UNITED STATES PATENT AND TRADEMARK OFFICE

APPLICATION NO.	FILING DATE	FIRST NAMED INVENTOR	ATTORNEY DOCKET NO.	CONFIRMATION NO.
10/650,416	08/29/2003	David Edwin Zapp	DEZ 001 P2	6570

Office Action Summary

DETAILED ACTION

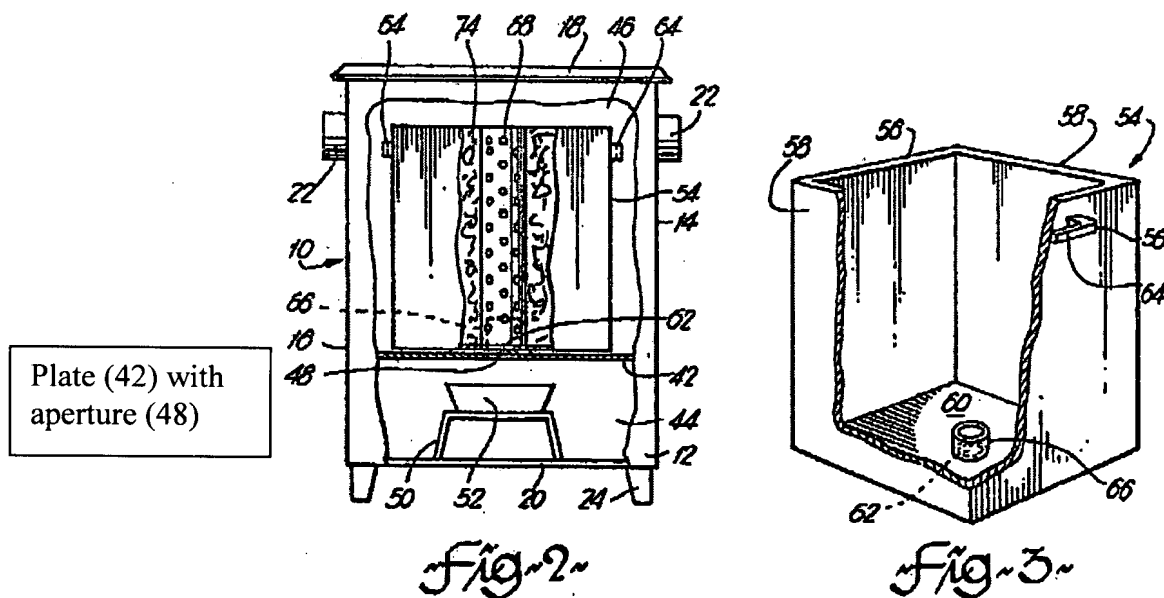
In regard to claims **1, 3, 12, 13, 16** and **19**, **US004338915 (Martonfi)** shows and discloses a charcoal fire starter including:

- a first chamber (10) having:
 - a sidewall (12, 14, 16, etc.);
 - a top edge (not referenced; contacting the top wall 18);
 - a bottom surface (20); and
 - a planar member (42, a grate (note shown; Note: "Open 50 can be replaced by a small grate (not shown) if the secondary combustion material is to be wood shavings, twigs, paper or the like.") disposed horizontally intermediate the top edge (at 18) and the bottom surface (20);
 - the planar member having at least one aperture (48) extending from a top surface to a bottom surface;

- only one sidewall (12) having an aperture (34) formed therein intermediate the bottom surface (90) and the planar member (28); and
- a second chamber (54; figure 3) disposed above (figure 2), supported on and in cooperating relationship with the first chamber planar member (42) and having:
 - a sidewall (56, 58);
 - a top edge (not referenced); and
 - a planar charcoal supporting bottom surface (60) extending across the second chamber; and
 - the second chamber having one aperture (62, 66) formed therein; and
 - updraft facilitation means (68) atop and in contacting relationship to the second chamber charcoal supporting bottom surface, wherein the updraft facilitation means and spaced in totality inwardly of the second chamber sidewall, and having a sidewall with a plurality of apertures (70) extending therethrough.

U.S. Patent Oct. 28, 1975 Sheet 1 of 4 3,915,144

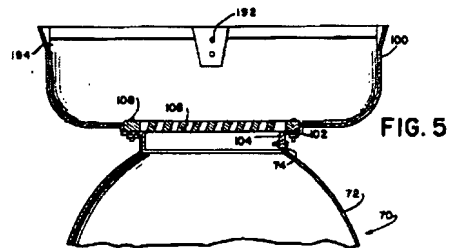
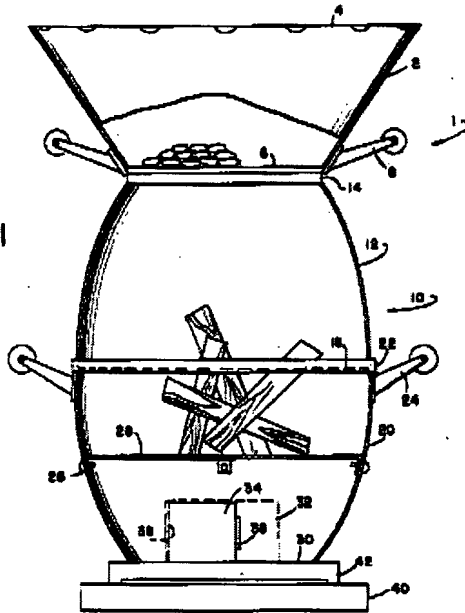
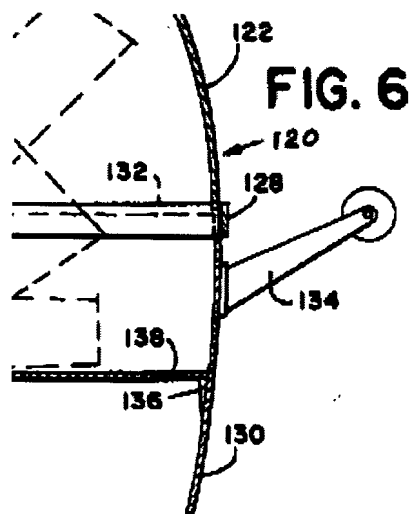
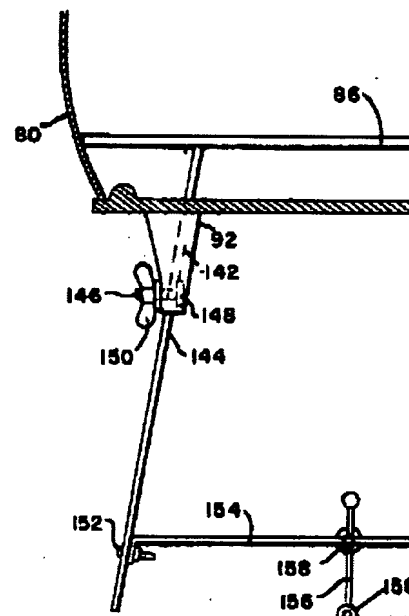
- a first chamber (20; 80; 130) having:
 - o a sidewall;
 - o a top edge (not referenced; contacting "Lower end 16"), and
 - o a bottom surface (90; see for example figure 8); and

- o a planar "grate" member (28, or 138) disposed horizontally intermediate the top edge (at 16) and the bottom surface (90);
 - o the planar "grate" member having at least one aperture extending from a top surface to a bottom surface (see for example planar "grate 106" (figure 5));

- o the sidewall (20) having at least one aperture (38) formed therein intermediate the bottom surface (90) and the planar member (28), and
- a second chamber (2,12; 52,72; 100,70; 112,122) disposed above and in cooperating relationship with the first chamber (20; 80; 130) and having:

- o a sidewall;
 - o a top edge (4); and
 - o a planar charcoal supporting bottom surface (i.e. – grate 6, or 106) extending across the second chamber and located above the first chamber planar member; and

- o the second chamber having at least one aperture formed therein (i.e.- the apertures necessarily present in the planar bottom surface grate 6, or 106).

In regard to claim 3, it is noted that the first chamber planar member (28) of **US003915144 (Tomita)** is a "grate" which necessarily includes apertures throughout its planar extent (for an example of a planar "grate" see element 106 of figure 5). Therefore any one of these grate openings, or apertures, located centrally of the grate meets the claim limitation that the "planar member has formed therein a centrally positioned aperture".

In regard to claim 5, the second chamber of **US003915144 (Tomita)** has a **flange member**, the flange member (22, or 128; see figure 6) forming the bottom edge of the second chamber sidewall, the flange member telescoping with the top edge (16, or 132) of the first chamber.

5,197,455

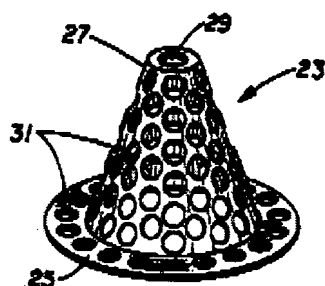
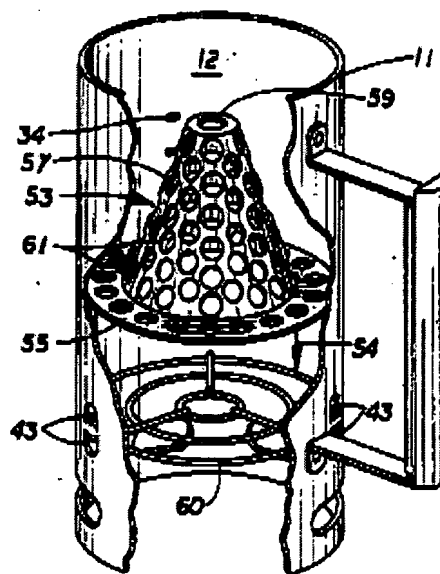
US005197455 (Tessien) teaches, from applicant's same charcoal ignition field of endeavor, placing a charcoal ignition draft facilitating means (11, 12) within a cooking grill for aiding in the initial ignition of the charcoal.

A. N. DURFEE
CHARCOAL IGNITER
Filed July 22, 1963

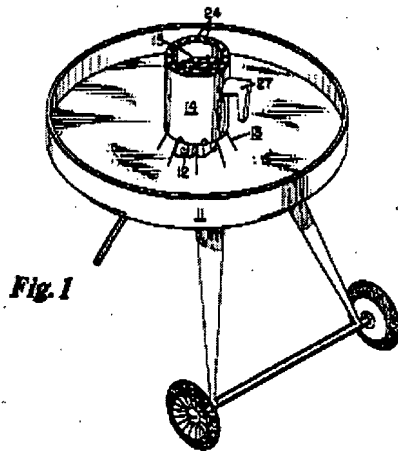
US003216379 (Durfee) teaches, from applicant's same charcoal ignition field of endeavor, placing a charcoal ignition draft facilitating means (14) having a plurality of support legs, within and supported on a cooking grill (11), for aiding in the initial ignition of the charcoal.

3,934,520

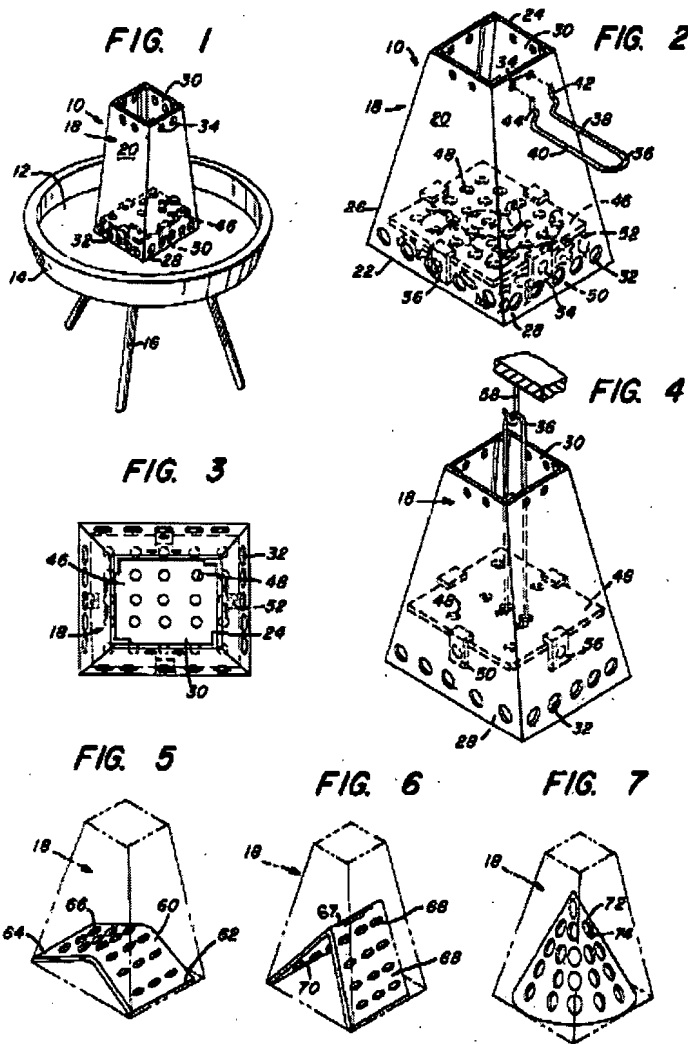
US003934520 (Brennen et al) teaches, from applicant's same charcoal ignition field of endeavor, placing a charcoal ignition draft facilitating means (10) having a plurality of support legs (21), within and supported on a cooking grill (12, 14), for aiding in the initial ignition of the charcoal.
